#### **ADDENDUM**

Project: Camp Ben Lomond Eating Shelters Project No.: 533-4012-24020101 Addendum No.: 03

Project Address: 2635 East 5100 North, Liberty, Utah Date: October 20, 2025

C811

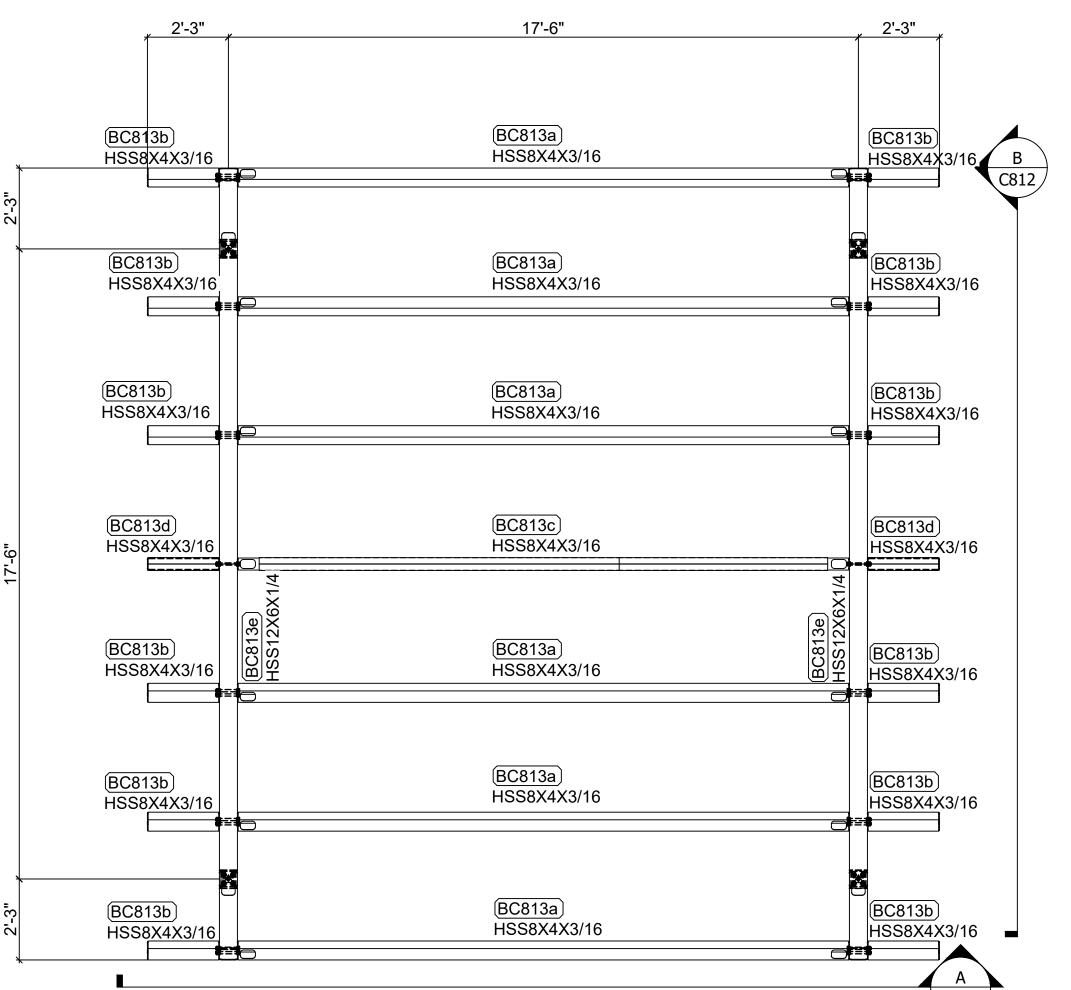
- 1. Changes to prior Addenda:
  - a. None
- 2. Changes to Bidding Requirements:
  - a. None
- 3. Changes to Conditions of the Contract:
  - a. None
- 4. Changes to Specifications:
  - a. None
- 5. Changes to Drawings:
  - a. C811-C813 Pavilion
     See the attached revised drawings for changes to the concrete and reinforcing requirements.
